**Further Supplementary Individual Expert Report –
Groundwater conceptualisation and quality**

Dr Matthew Currell

REGISTRY: Brisbane
NUMBER: EPA495-15
MRA496-15
MRA497-15

Applicant: NEW ACLAND COAL PTY LTD ACN 081 022 380

Figure 1 – Comparison of fault locations in the AEIS groundwater model following the IESC’s 2014 advice (a) and immediately prior to IESC’s 2016 advice (b).

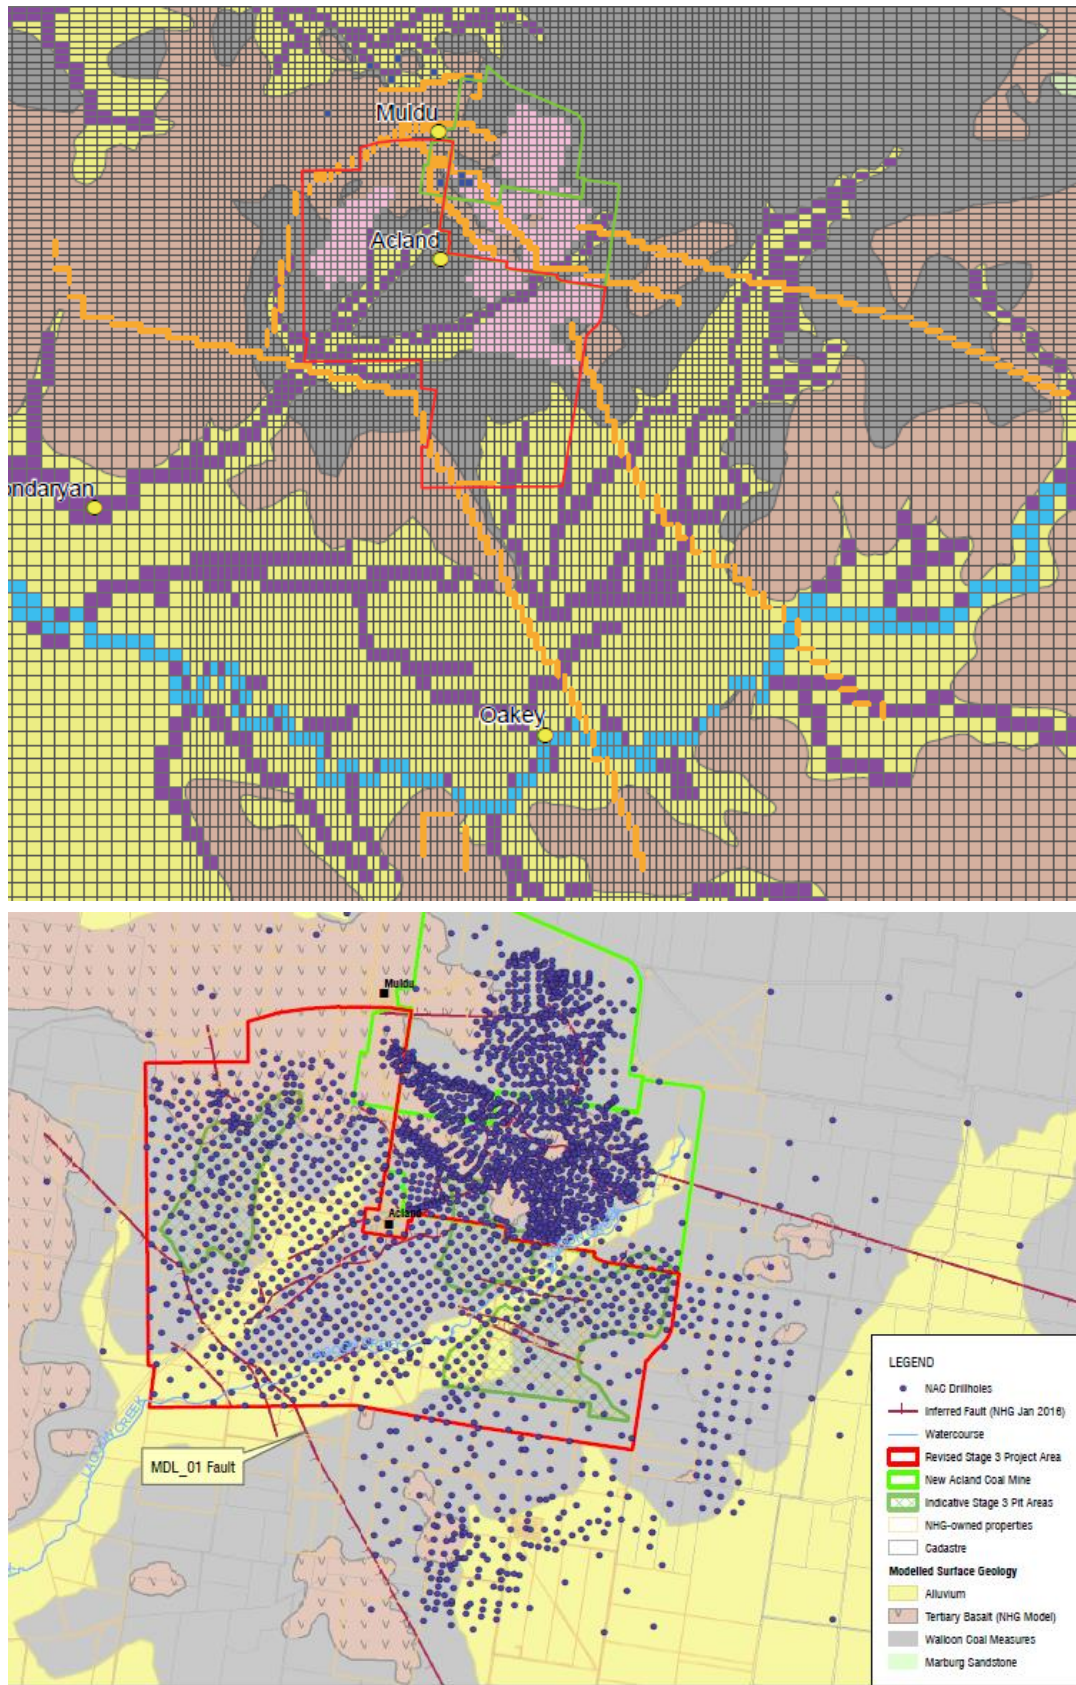
- (a) The observation that many of the faults in the AEIS numerical model don't match the drilling and mapping data. This is yet to be resolved and incorporated into a new conceptual or numerical model of the site (see figure 1, below);

- [40] Regarding the first issue (paragraph (a) above), it is clear that the inferred faults shown on the map in SLR 2016a and SLR 2017 are quite different from the pattern of faults in the AEIS model that was reviewed by the IESC in 2014 and updated in response to their advice. The maps below show a comparison of locations where faults were included in the model at this time (in orange), compared to those mapped in the recent SLR reports (SLR 2016a & SLR 2017):

[41] As can be seen from this comparison, a number of faults in the AEIS model occur in places where they are not mapped in the field, or with significantly different orientations and extent

- [43] Importantly, the 'sensitivity analysis' of the effect of faulting presented in SLR 2016a still uses the previous conceptualisation of faults presented in 2014 and 15 (top image of figure 1) rather than a conceptualisation which has the faults located in the model where they were mapped in the field (the bottom image of figure 1, and figure 2, above). Consequently, the IESC's comment in 2016 that a '*Sensitivity analysis on the role of faulting has been undertaken within the groundwater model by removing the horizontal flow barriers that represented faults*' in my opinion gives a false impression that a rigorous sensitivity analysis of the effect of faulting has been conducted. The significant difference between the faulting pattern in the AEIS model and the actual field data will require (as foreshadowed in the SLR

- [67] As is clear in the AEIS (see Figure 1 above), the most recent version of the groundwater model in fact contains representations of many more than five faults within the project area. In this version of the model, all of these faults are represented as complete barriers to groundwater flow, or in a manner which doesn't allow the modeller to control their hydraulic behaviour (e.g. faults included as 'walls' with gaps selectively added between adjacent cells).

2016b report) a re-build of the hydrogeological conceptualisation with faults included in correct locations, with more appropriate hydraulic properties (and a range of possible properties tested in the modelling), before a thorough sensitivity analysis of the effects of faulting can be completed. The results of this sensitivity analysis will also be impacted by changes in the layering and hydraulic parameters of the aquifers in the model, and revised water balance. As with other aspects of the hydrogeological conceptualisation and model, it can be expected that this new conceptualisation would lead to significantly different predictions of groundwater impacts from the project compared to the AEIS, with significant implications for groundwater users.

Figure 2 - Pattern of faulting provided by NAC to B. Barnett during development of EIS groundwater model (from Brian Barnett's statement of evidence, 10/05/2016¹⁶).

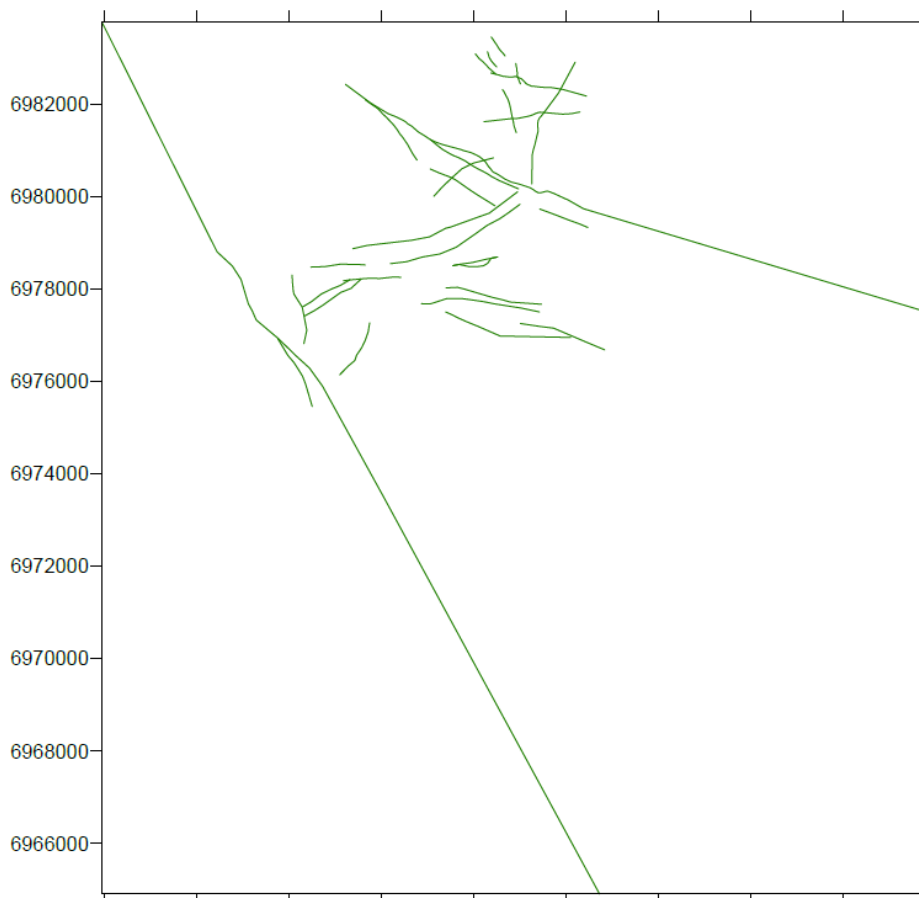
(as discussed in my supplementary expert report of 6/5/2016¹⁵). Additional faults occur in the field mapping but are not included within the model. The map of faults included within the SLR 2016a and 2017 reports is in fact very similar to the map of faults that was provided to SKM during development of the original groundwater model prior to 2013:

- [42] Much of the mapping of the faulting pattern presented in SLR 2016a thus appears to have already existed and to have been provided to the consultants during development of the original groundwater model for the EIS and AEIS. It is thus not clear how much additional drilling (other than the new monitoring bores described in SLR 2016a and SLR 2016b) has taken place since the AEIS model to characterise the faulting pattern beyond that already provided (on the basis of coal exploration bore logs) during the initial groundwater model development.
